Work Order ID 88102

Item Name: Door Prop

Reference: ECN 12-624

DRAWING NO. D3552
REV. K
SHEET 1 OF 2
TITLE DOOR PROP
SCALE NTS

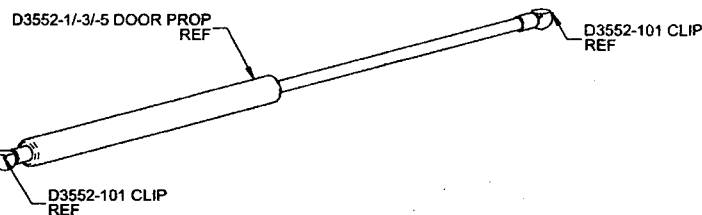
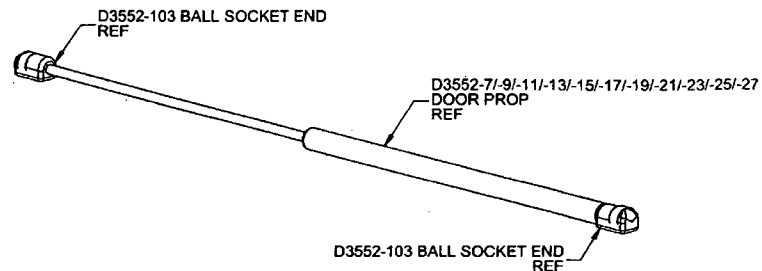
REV.	DESCRIPTION	BY	DATE
K	ADD "X" TO LS TECHNOLOGIES P/N'S TO DESIGNATE "EXTRA DAMPING" FOR D3552-15/-17/-19/25/-27. REASON: PAR12-209.	MB	12.07.16
J	ADD P/N D3552-25/-27. REMOVE ALTERNATE PART NUMBER FOR -15, -17 AND -19. STROKE FOR -15, -17 AND -19 WAS 139/6.06 NOW 154/6.06. EXTENDED LENGTH FOR -15, -17 AND -19 WAS 386/15.2 NOW 387/15.2.	AP	11.12.07
I	ADD P/N D3552-23	RF	11.10.11
H	ADD P/N D3552-21	DC	11.03.10
G	FOR -15, FORCE: 300/67.4 WAS 400/89.9, SUPPLIER P/N B8-154-387-300N WAS B8-154-387-400N; FOR -17, STROKE: 139/6.47 WAS 160/6.30, EXT LG: 386/15.2 WAS 407/16.0, SUPPLIER P/N B8-154-387-156N WAS B8-167-408-156N	JPH	10.11.01
F	ADD P/N D3552-15/-17/-19 AND ALTERNATE SUPPLIER	JPH	10.07.27
E	ADD P/N D3552-13 ZN B8-1, A8-1, D6-1, CHANGE NAME FROM "GAS SPRING" TO "DOOR PROP" THROUGH OUT DWG	HS	10.02.03
D	ADD P/N D3552-101 ZN D6-1, C7-1, C1-1 AND D3552-103 ZN D1-1 AND C2-1 AND ZN B8-1; ADD NOTE REGARDING D3552-101 AND D3552-103 COMPATIBILITY ZN A8-1	HS	09.04.02

D3552-15	DOOR PROP W/EXTRA DAMPING	154/6.06	387/15.2	300/67.4	10mm NYLON BALL SOCKET	CARBON STEEL	LS TECHNOLOGIES	B8-154-387-300NX
D3552-17	DOOR PROP W/EXTRA DAMPING	154/6.06	387/15.2	156/35.1	10mm NYLON BALL SOCKET	CARBON STEEL	LS TECHNOLOGIES	B8-154-387-156NX
D3552-19	DOOR PROP W/EXTRA DAMPING	154/6.06	387/15.2	60/13.5	10mm NYLON BALL SOCKET	CARBON STEEL	LS TECHNOLOGIES	B8-154-387-060NX
D3552-21	DOOR PROP	167/6.57	410/16.1	70/15.7	10mm NYLON BALL SOCKET	CARBON STEEL	LS TECHNOLOGIES	B6-167-410-070N
D3552-23	DOOR PROP	190/7.48	475/18.7	70/15.7	10mm NYLON BALL SOCKET	CARBON STEEL	LS TECHNOLOGIES	B6-190-475-070N
D3552-25	DOOR PROP W/EXTRA DAMPING	148/5.83	475/18.7	300/67.4	10mm NYLON BALL SOCKET	CARBON STEEL	LS TECHNOLOGIES	B8-148-475-300NX
D3552-27	DOOR PROP W/EXTRA DAMPING	148/5.83	475/18.7	156/35.1	10mm NYLON BALL SOCKET	CARBON STEEL	LS TECHNOLOGIES	B8-148-475-156NX
2 D3552-101	CLIP	N/A	N/A	N/A	N/A	CARBON STEEL	LS TECHNOLOGIES	C9
